PRODUCT SAFETY RECALL

SUBJECT: Diesel Fuel Transfer Pump Tube Nut Torque

MODELS: 2015 Chevrolet Silverado HD
2015 GMC Sierra HD
Equipped with Diesel Engine (LML) and Dual Fuel Tanks (N2N)

3749706

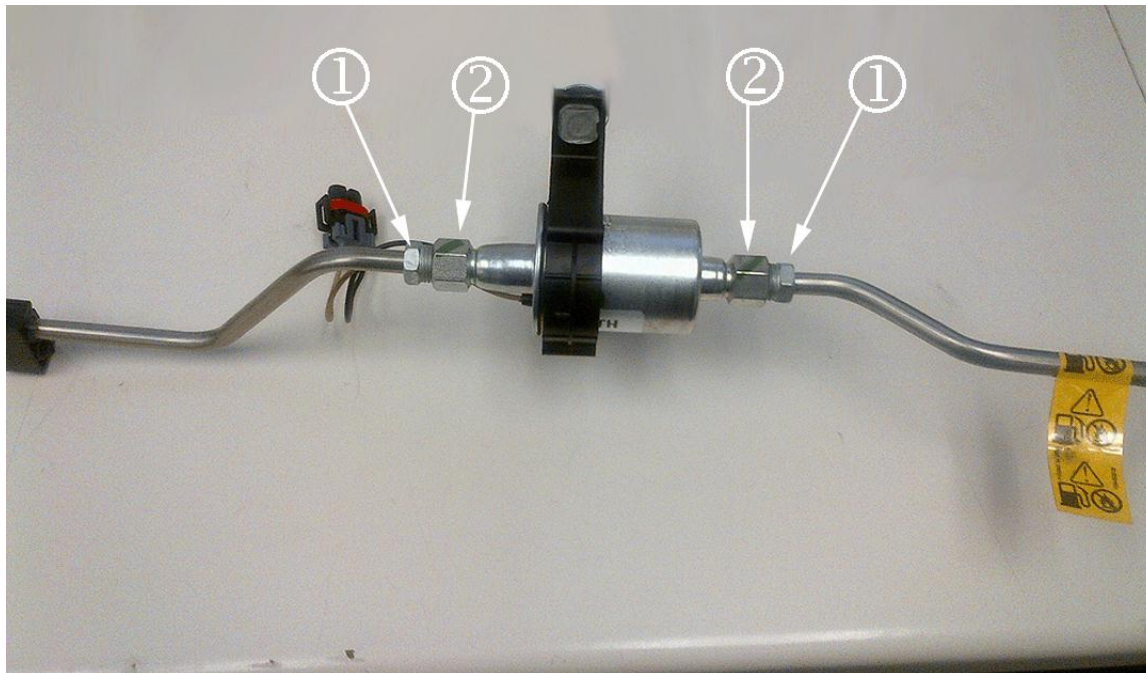
General Motors has decided that a defect which relates to motor vehicle safety exists in some 2015 model year heavy duty Chevrolet Silverado and GMC Sierra vehicles equipped with a diesel engine (LML) and dual fuel tanks (N2N). The fuel pipe tube nuts on each side of the diesel fuel transfer pump may not have been properly torqued. Diesel fuel may leak at the fuel transfer pump if there is fuel in the rear tank and the transfer pump activates to transfer fuel to the forward fuel tank. If there is fuel leakage and an ignition source is present, a fire could occur.

Note: Use a backup wrench to prevent the fuel transfer pump from turning. Hold the larger nut (2) in place while tightening the smaller tube nut (1).

3. Tighten the tube nuts (1) on both sides of fuel transfer pump to **30 Nm (22 lb-ft)**.
